Re: FCC ID RBT99061003

Applicant: PipeHawk Plc
Correspondence Reference Number: 26325
731 Confirmation Number: EA540369

Graph 1: NSA - Horizontal Polarization.

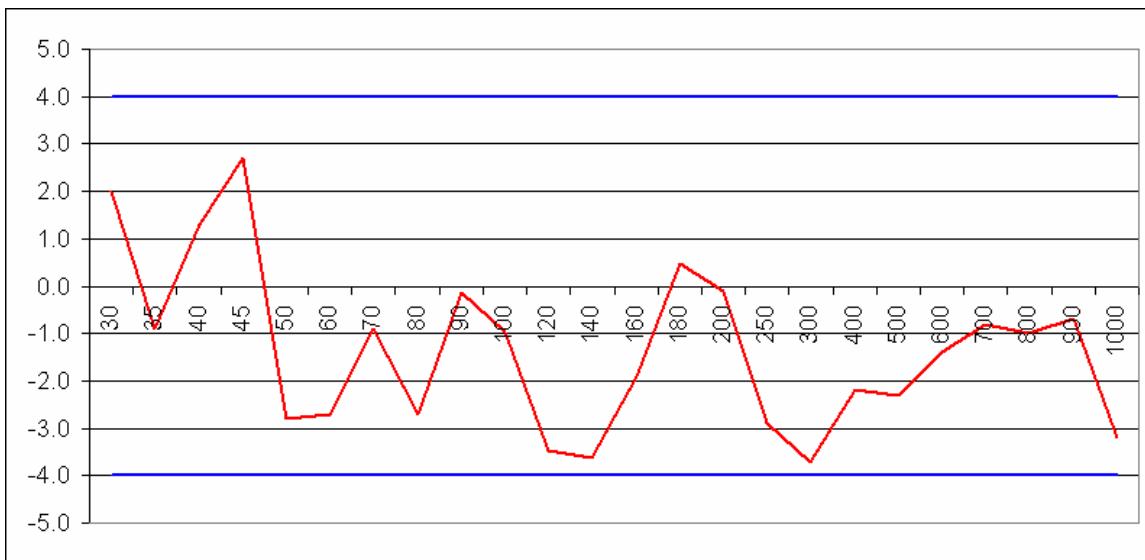
Quote: “1. You state that the ground plane is beneath the concrete slabs during tests. The photo's show this also. Remove these slabs and place a 20 inch bed of sand beneath the EUT. Do not put any ground plane beneath the device, remove it. Please retest. Please keep in mind the following and also past measurement issues.”

Response: I can confirm that the EUT was placed on a 20 inch bed of sand. The bed of sand was placed on a protective layer of none conductive stone slabs. The slabs are used to protect the ground plane.

The ground plane is none removable and was used in line with the FCC's own guidelines as stipulated by the FCC in there First Report and Order Docket 98-153 Appendix F (7) which states “*Field strength measurements may be performed without the use of a ground plane; however, a factor of 4.7 dB must be added to the measurement results thus obtained.*” This implies a ground plane may be used without the addition of 4.7 dB.

The stone slabs serve the purpose of protection for the ground and have no direct effect on the final result. The measurement is made in compliance with C63.4 5.4 & 5.5. The site attenuation also fits within the specified criteria of C63.4 5.4.6.3 confirming the lack of influence the slabs have on the final result. Please see the following graphs showing the NSA.
